CONSTRUCTION PLANS
FOR
**PONDEROSA AT
LORSON RANCH FILING NO. 3**
STREET/STORM SEWER AND UTILITY CONSTRUCTION PLANS

COVER SHEET
STREET/STORM SEWER
AND UTILITY PLANS

PUDSP-19-010

POND A3 - FOREBAY LAYOUT
SCALE: 1"=5'

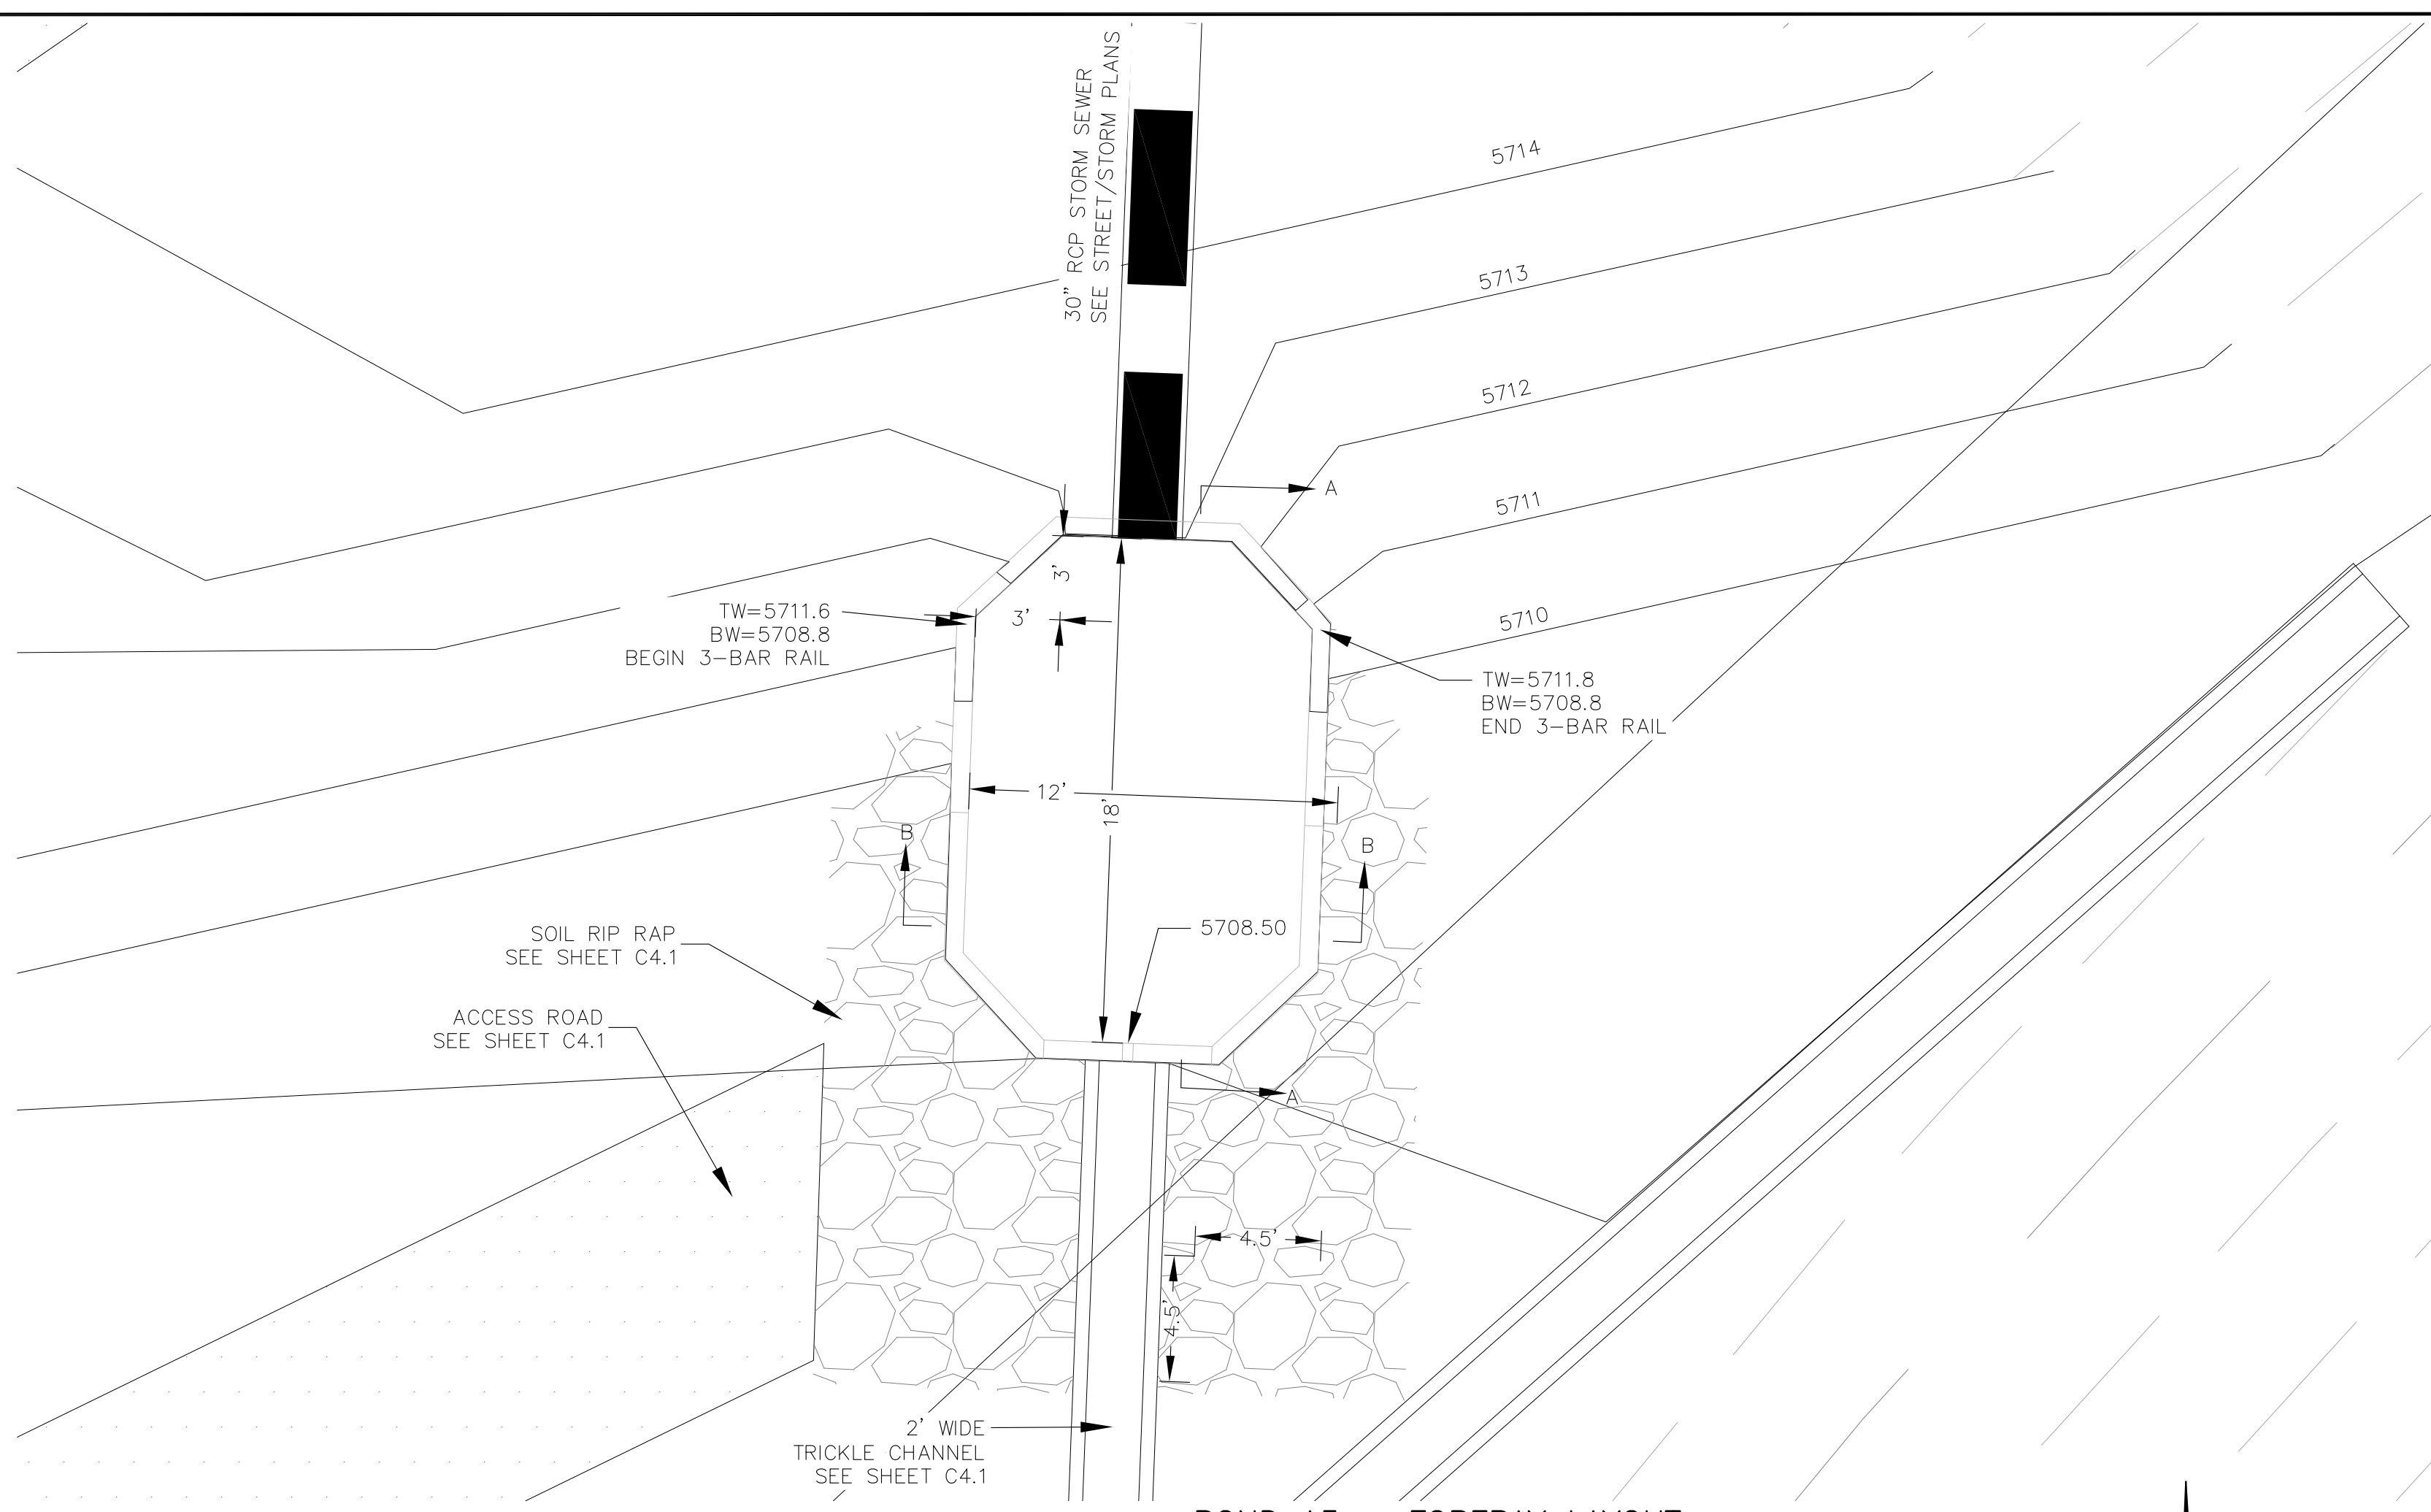
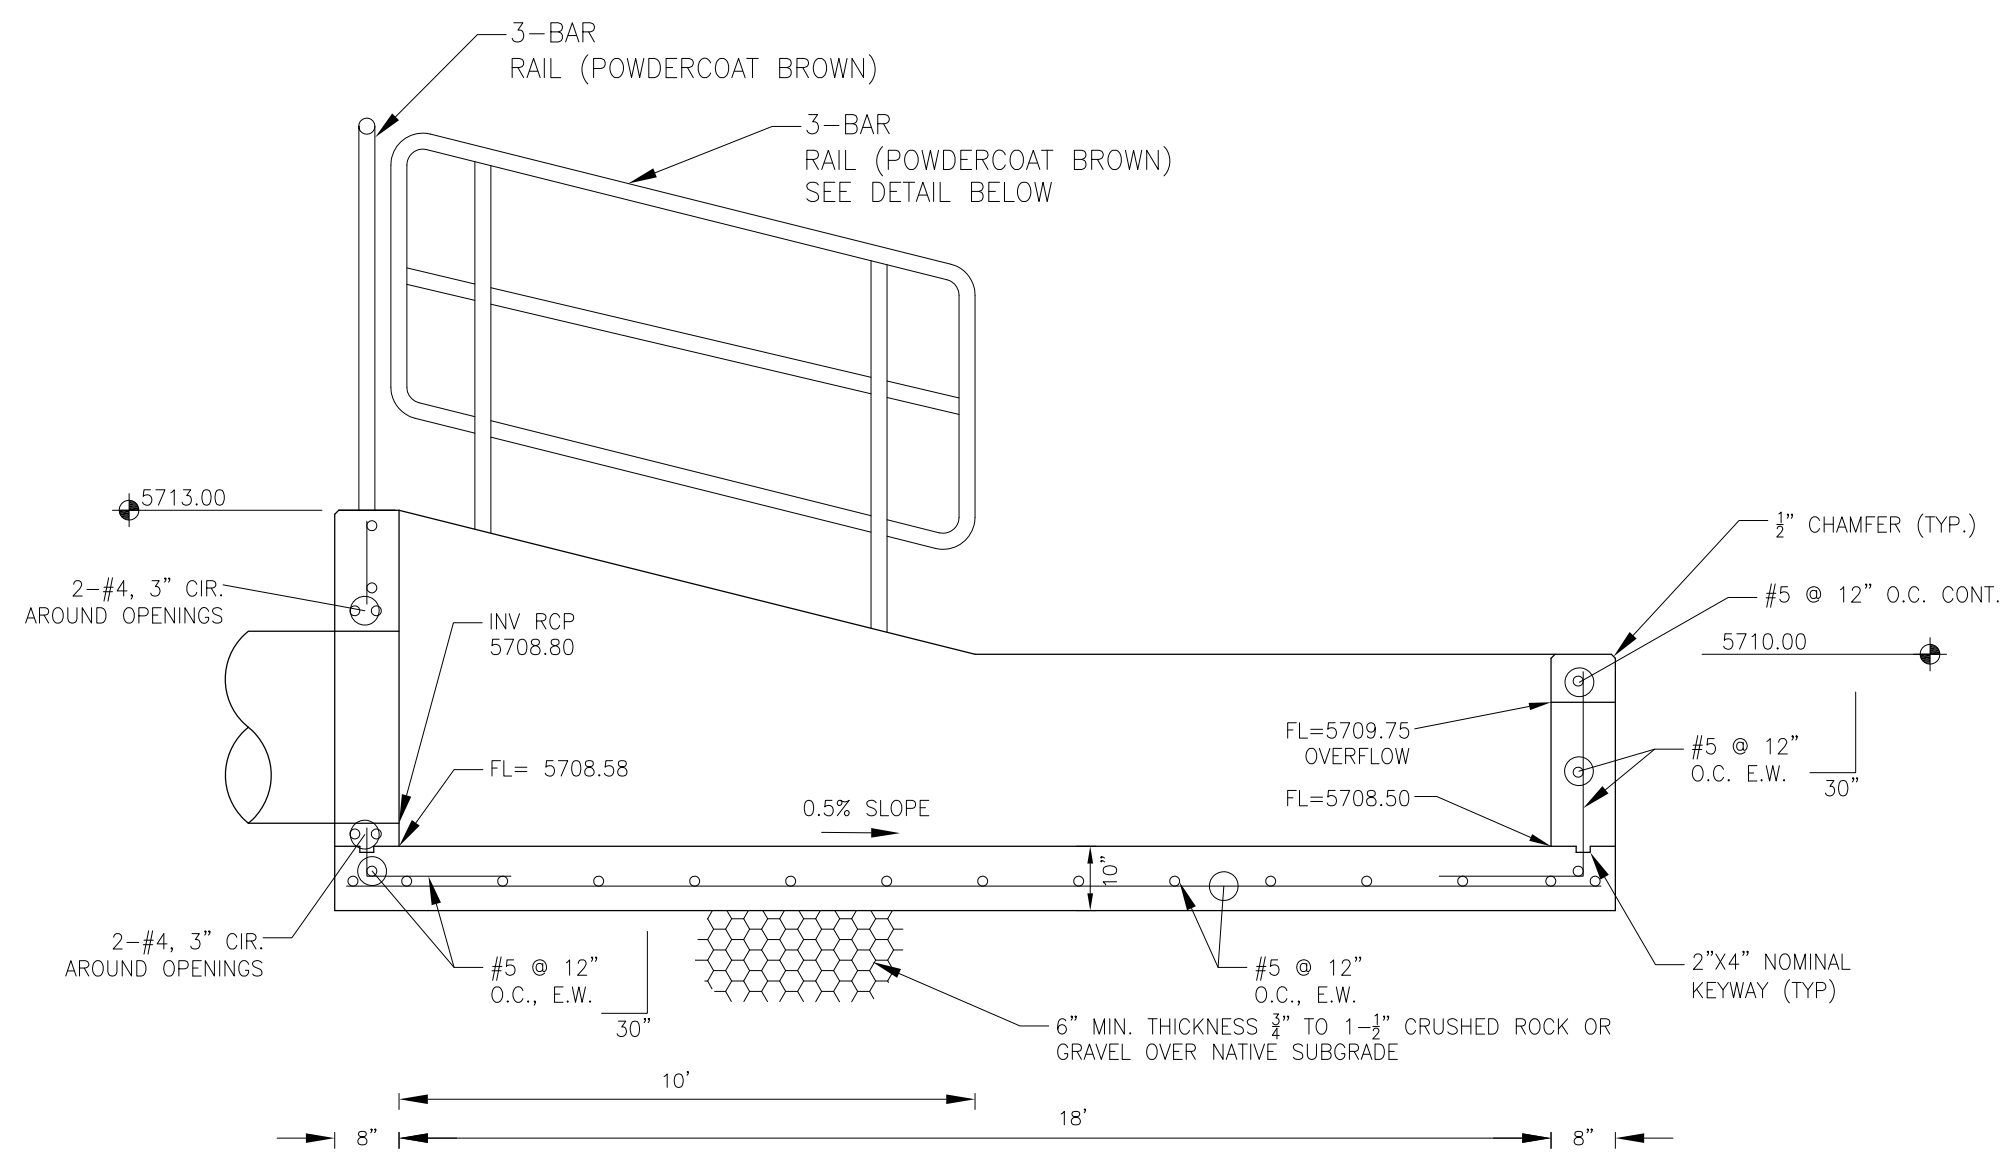
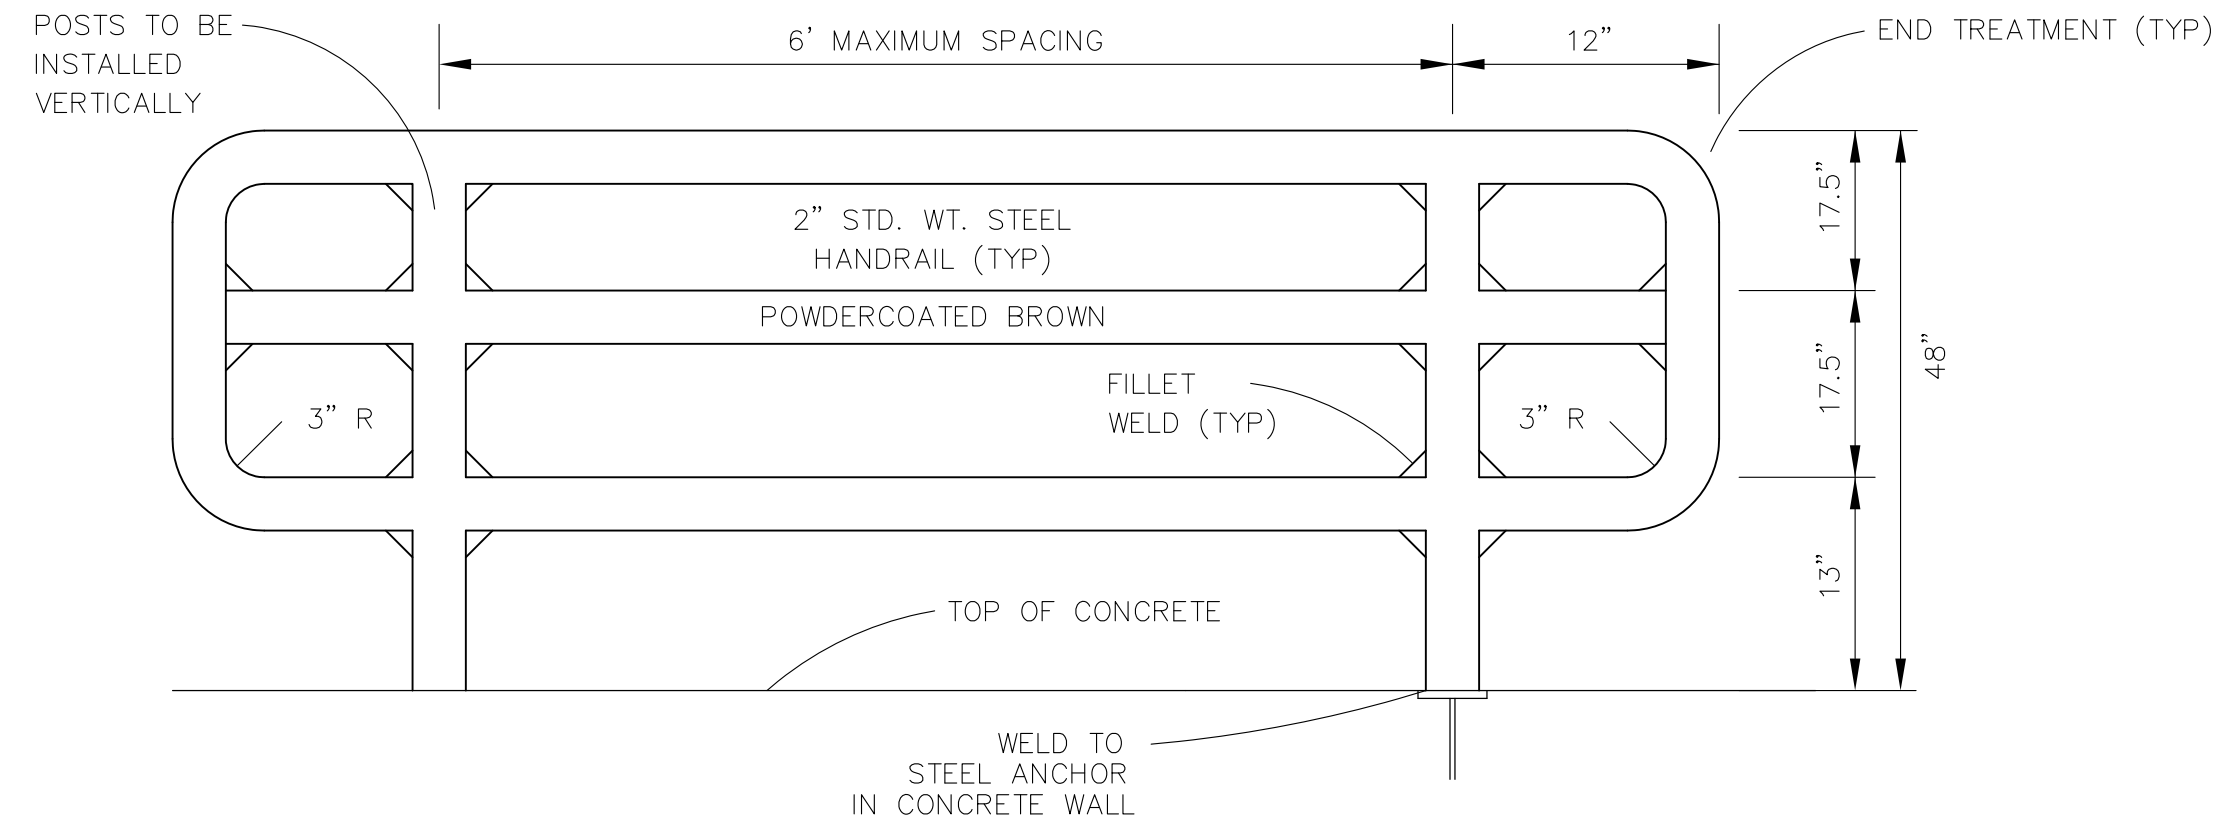
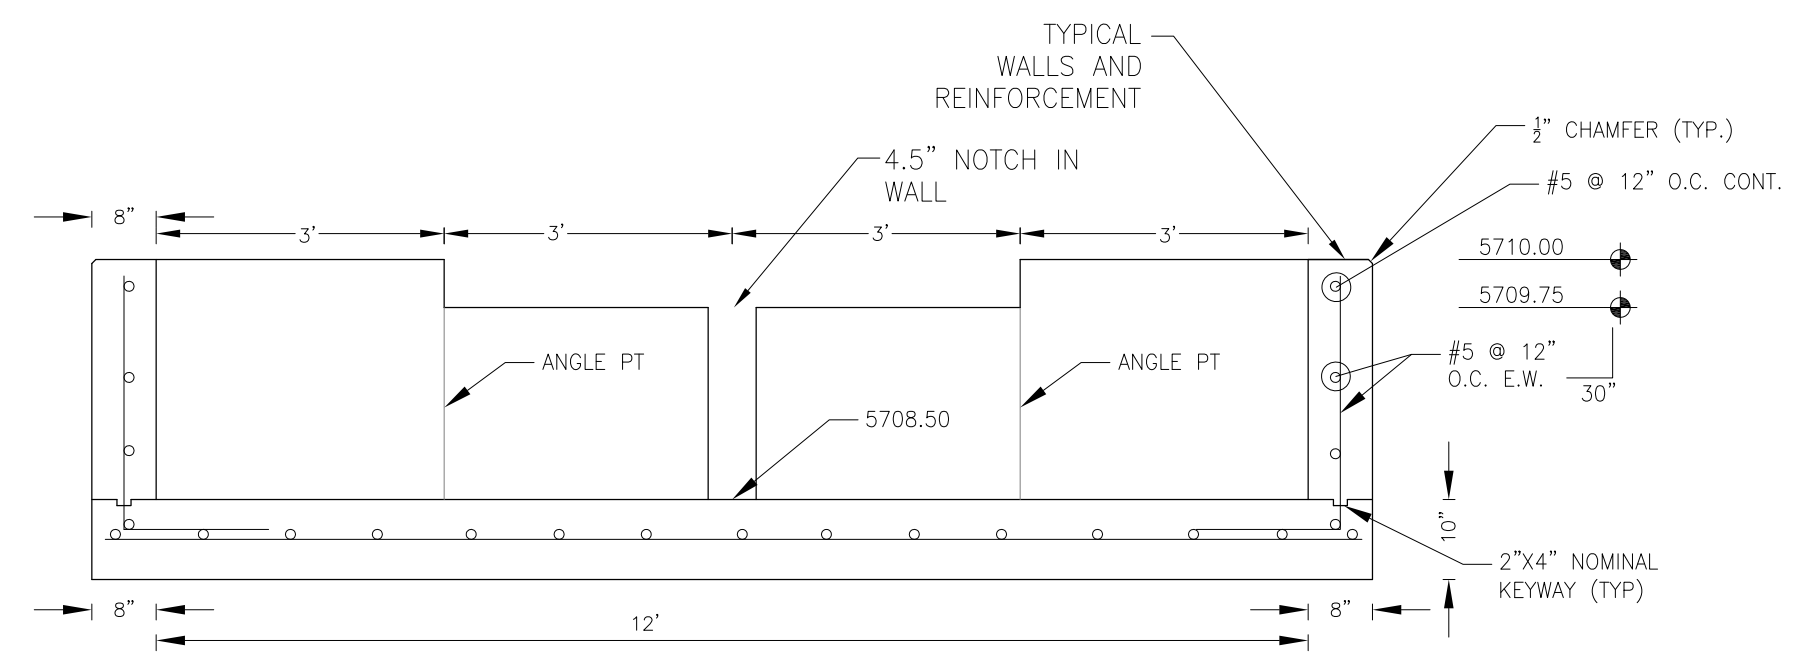
Duplicate sheet from the GEC.
See GEC Plan for redline comments.
Remove all duplicate sheets.
